Well Name: GALLEGOS FRTLD	Well Location: T27N / R12W / SEC 35 / NESW / 36.53108 / -108.08414	County or Parish/State: SAN JUAN / NM
Well Number: 1	Type of Well: OTHER	Allottee or Tribe Name:
Lease Number: NMNM57579	Unit or CA Name:	Unit or CA Number:
US Well Number: 300452823200S1	Operator: DUGAN PRODUCTION CORPORATION

Type of Submission: Notice of Intent      Type of Action: Plug and Abandonment

Procedure Description: Dugan Production plans to plug and abandon the well per the attached procedure.

AFMSS 2 Sundry ID 2813556

**Planned P&A Wellbore Schematic**

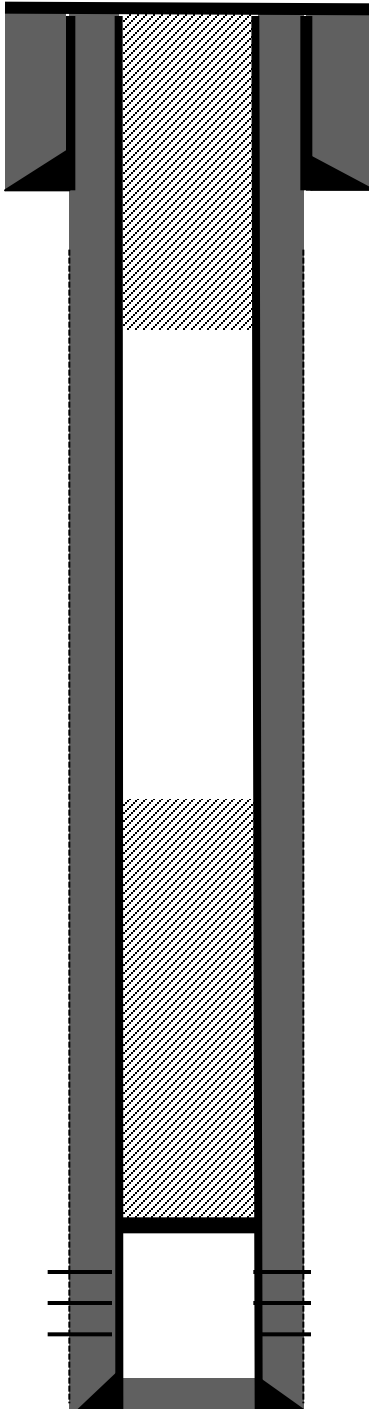
Created By	Condition	Condition Date
mkuehling	NMOCD call on tops Kirtland 300 Fruitland 955 PC 1288 -adjust plugs to accommodate all agencies - Notify NMOCD 24 hours prior to moving on - Monitor string pressures daily report on subsequent - Submit all logs prior to subsequent	10/2/2024
